Amendments to the Drawings:

REMARKS

FIG. 1
PRIOR ART

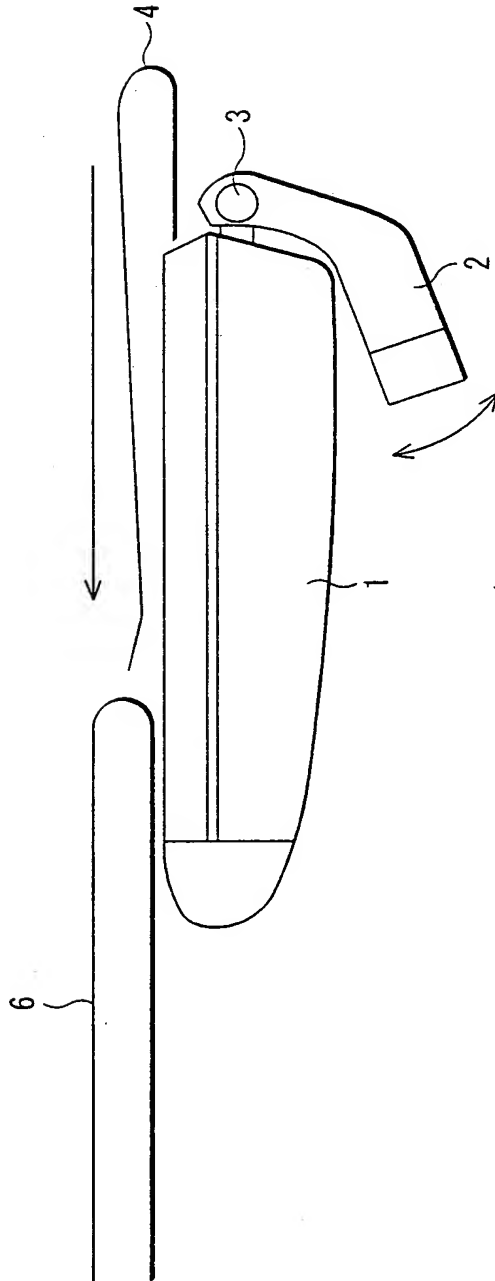
The specific changes which have been made to Figures 1 and 2 are to label these Figures as "PRIOR ART".

The drawings were objected to. Specifically, the Office Action indicated that Figures 1 and 2 should be designated by a legend such as --Prior Art--. Figures 1 and 2 have been amended to label them as "PRIOR ART". Accordingly, applicants submit that the objection has been overcome.
